DEVELOPMENT ASSESSMENT REPORT

DEVELOPMENT APPLICATION DA31/2013

BELMORE STREET, CONDER STREET AND WYNNE AVENUE, BURWOOD

CLIENT: BURWOOD CITY COUNCIL

Figure 4: Building height line applied to Building A

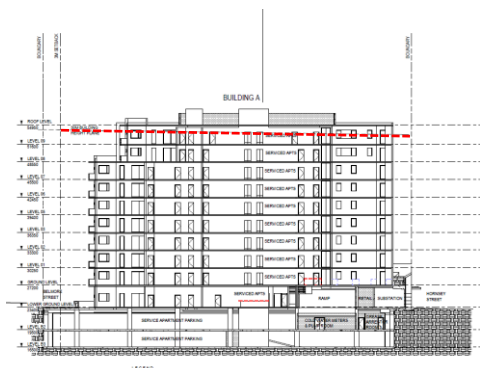
With respect to the non-compliance for Building A the applicant has justified the variations to the height for Building A with the following explanation:

"Building A (Site A) exceeds the 30m height plane (measured along Conder Street) by between 0.9 and 1.6m ...The building heights have been developed and modelled based on an analysis of the most effective built form outcome for the Town Centre utilising opportunities offered by the large consolidated site. It is noted that while the proposed design includes minor height non-compliances the overall design has been modelled to eliminate any adverse impacts in relation to the additional height. In particular, it is noted that the shadow profile of the proposed building is less than that generated by the permissible building envelope for the site."

The proposal complies with the objective of providing a development of increased density in an area nominated by Council's planning controls for redevelopment. The adverse effect of overshadowing has been adequately addressed. In addition, Building A complies with the relevant guidelines for separation and maintenance of privacy and amenity within the site and for adjoining and surrounding development. The visual impact on the streetscape has been reviewed by GMU and determined to be satisfactory. Overall Building A is considered to achieve the objectives for height control standards despite minor non-compliance with the 30m height standard.

Figure 9: Shadow impacts on northern elevations of buildings in Belmore Street

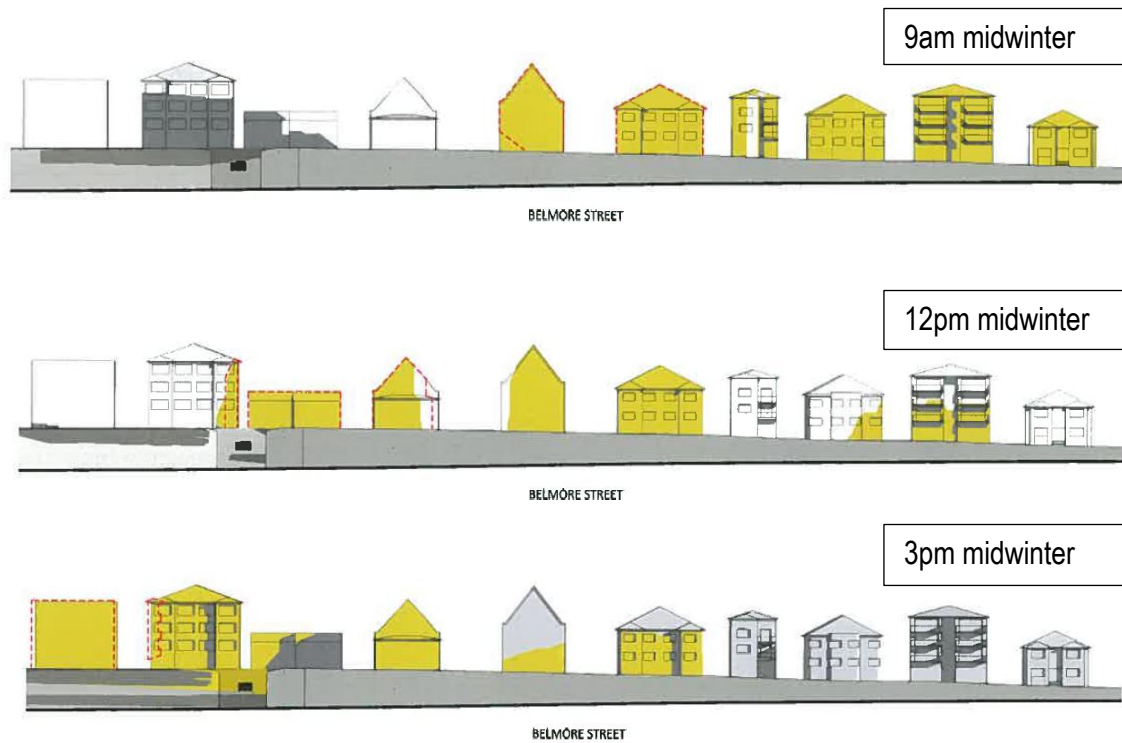
The shadow diagrams submitted by the applicant indicate that properties on the southern side of Belmore Street between Conder Street and Wynne Avenue shall be subject to some degree of

overshadowing between 9.00am and 3.00pm mid winter but are largely unaffected for the majority of the year. The duration of overshadowing in midwinter still allows for a minimum 3 hours solar access for most of these properties as can be seen from the shadow diagrams in Figure 9 and the shadow cast by the proposal (shaded yellow) is not as extensive as that for a compliant building mass for Building C (outlined in red).

Diagram showing location of service corridor (adapted from DA110/C Courtesy of KannFinch)

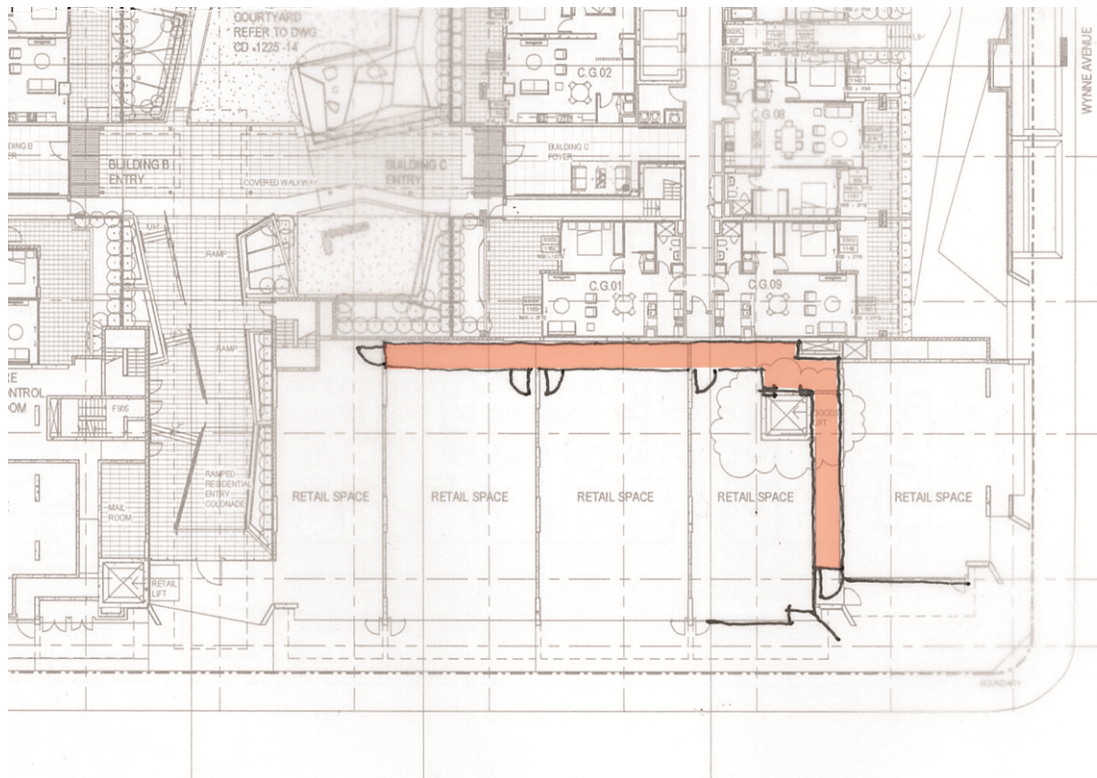
Access and Servicing - A direct route between the retail tenancies along Belmore Street and the garbage store has been improved with the inclusion of a dedicated service lift at the corner of Wynne and Conder Streets; however, access to the service lift lobby is still achieved through the public domain. As a differed condition of consent, the proposal will be required to provide an access corridor to connect the back of the retail tenancies to the lift in a similar way as shown in the diagram below. The door to the corridor visible from the corner of Belmore and Wynne Avenue is to be flushed with the wall or slightly indented so as to avoid being visible from the corner.
